**DA NO:** DA-2022/4

**ADDRESS:** 105 ARTARMON ROAD, ARTARMON NSW 2064.

**PROPOSAL:** PARTIAL DEMOLITION OF EXISTING DWELLING AND GARAGE WITH RETENTION OF FRONT FACADE, SYMPATHETIC RECONSTRUCTION OF GARAGE AND PART OF DWELLING FAÇADE, TWO STOREY ADDITIONS, FENCING AND ASSOCIATED WORKS.

**REPORT DATE:** 18 October 2022

The amended design was renotified with a significant reduction in submissions as discussed within the report. These plans are subject to the enclosed assessment. Below is the proposed floor plan showing the areas of retention and like-for-like rebuild.

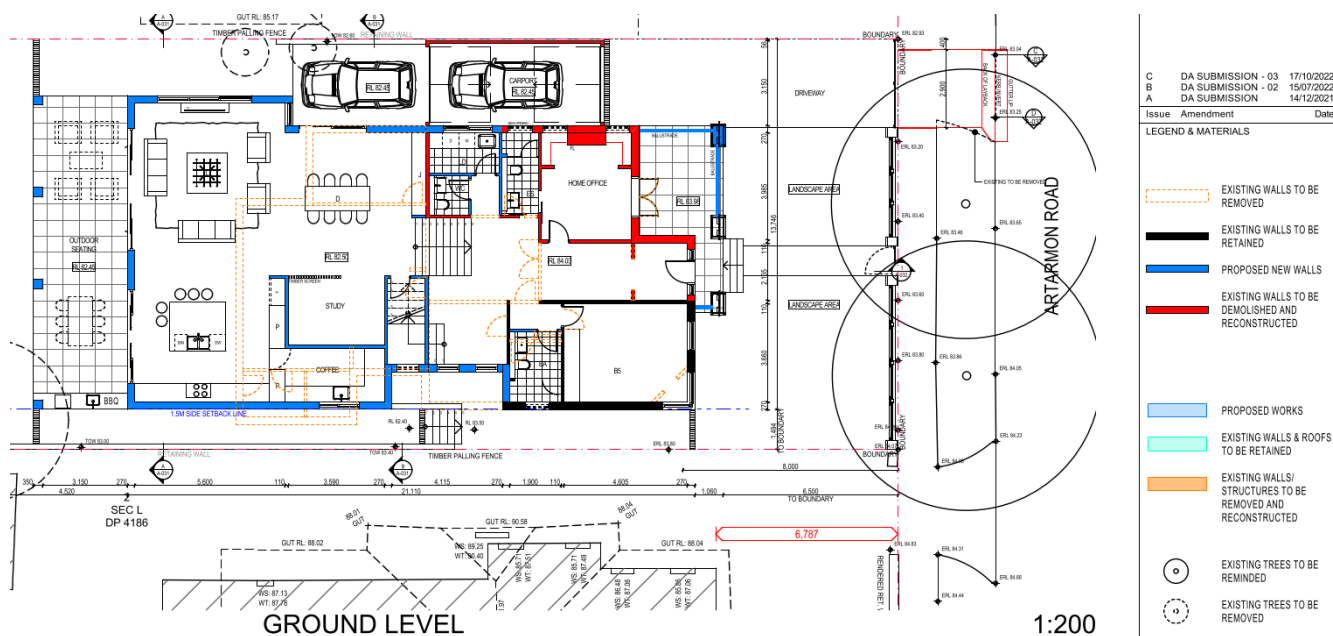
- Retention of a portion of the front facade
- Like-for-like reconstruction of the other portion of the facade and roof that needs to be structurally reinstated.

- Amended rear addition to be more in line with the heritage controls and character. Also addressing overlooking concerns.
